CLATSOP COUNTY

Southwest Coastal Design Review / Citizen Advisory Committee Regular Meeting Agenda

4. CONSIDERATION OF MINUTES (6:15-6:20 p.m.):
 - o Minutes of April 18, 2012 regular session (Chair) (*Attachment 1*)
5. ACTION ITEM (6:20-7:00 p.m.):
 - o Major Design Review: Application by Ryan Schenk, on behalf of Charles and Nancy Cobb, for review of application to construct a new bedroom and bath addition above a garage, replace windows, replace roof to match existing roof in design, remove chimney, and perform foundation work to halt settling of a single-family residence on property owned by the Cobbs, located at 80220 N. Pacific Road, Arch Cape, Oregon, also known as T4N, R10W, Sec. 19CC, TL 501. Staff: Julia Decker, Planner. (*Attachment 2*)

4 BUILDING SECTION
1/4" = 1' - 0"

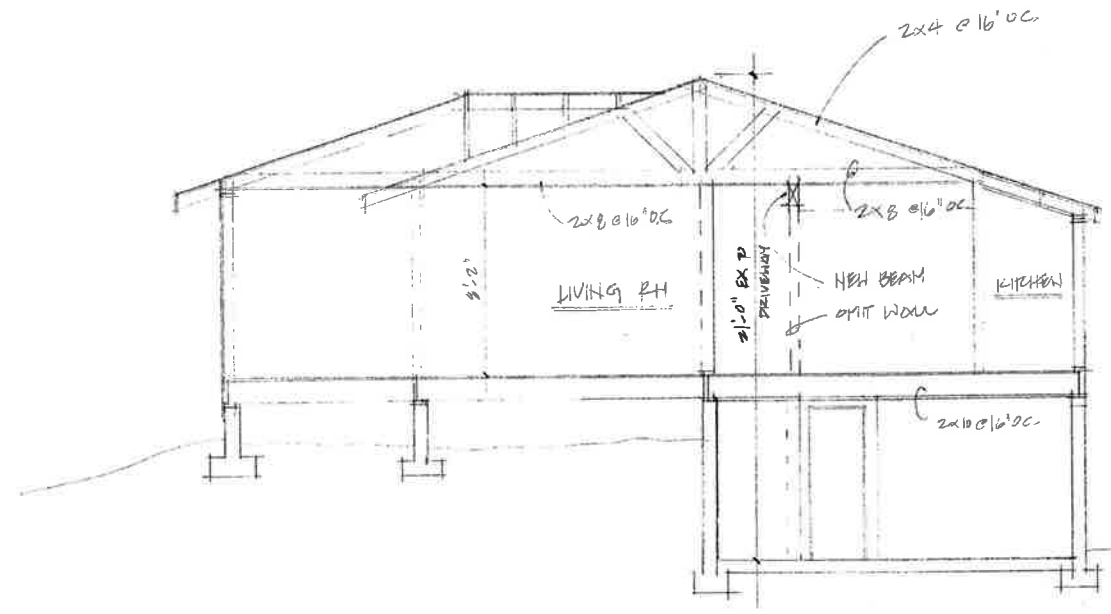
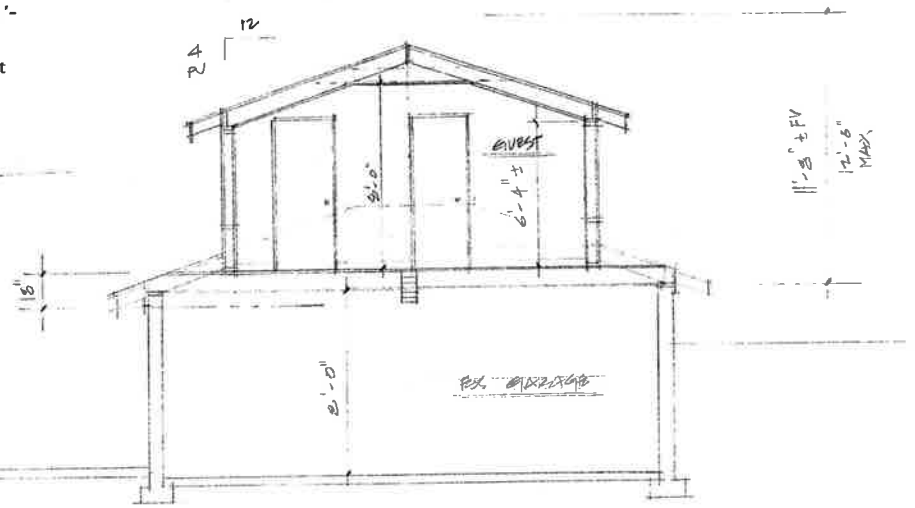
I would appreciate any information that the contractor wishes to send, and he may photograph the project from our property. There are two items I have questions about. Exactly what point or points is average grade measured from? Also, isn't having a surveyor measure the project once it is completed too late?

The height of the addition is limited by code to 12'-6" above the ceiling of the garage. The new construction will be 11'-8" +/- above the ceiling of the garage.

North Coast Survey has confirmed height measurements and will verify that the height is within the restricted height during construction.

The light gray over the garage shows the new addition. The chimney in the center of the roof is proposed for removal, and the plans state the peak of the addition's roof would be at or below 18 feet, as measured from average grade. One of the conditions of approval will be that the height is surveyed by a professional surveyor after completion to ensure the maximum height is not exceeded.
